Bulletin No.	TS82-011A
Date	March 7, 1982
Classification	ST82-001A
Section	Steering
Models	Maxima, 280ZX

STEERING GEAR (RP 15L AND 1PRP15L)

Applied Model: 910 and S130 Series

Modification Notice

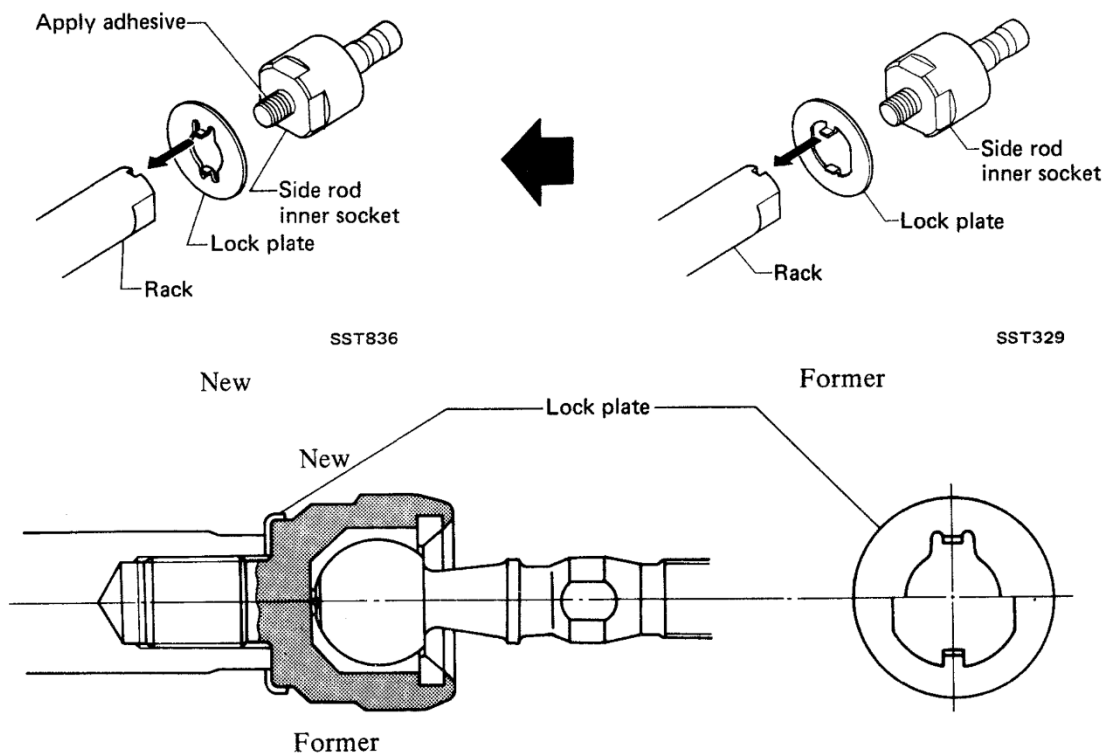
1. The lock plate has been redesigned and the length of the rack has been changed. Also a bonding agent has been applied to the threaded portion of the side rod inner socket. (910: IPRP15L)

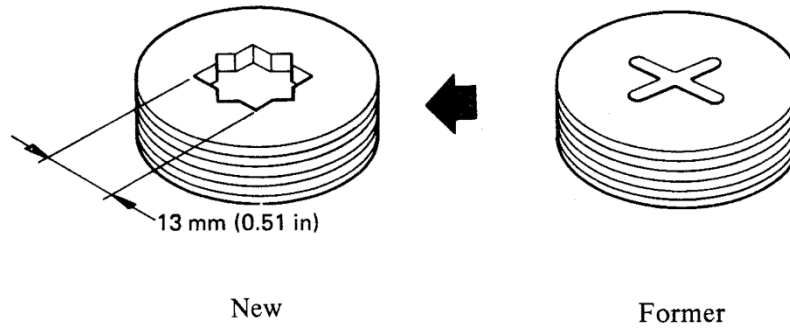
2. The retainer adjusting screw has been redesigned.
 (910, S130: IPRP15L) S130: IPRP15L)

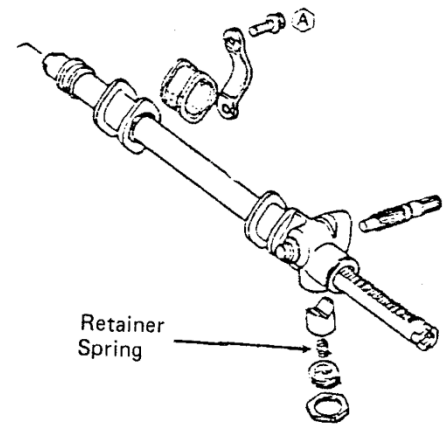
Rack Starting Force of power steering from the neutral position has been increased as follows.

Rack Starting Force (Kg)	
	New	Former
Power Steering	12.5—19.0	9.0—15.0

Part number of retainer spring, power steering.

Power Steering	Part No.	48237-W1000	48237-W1400
	Setting Spring Tention	19.4 Kg	8 Kg
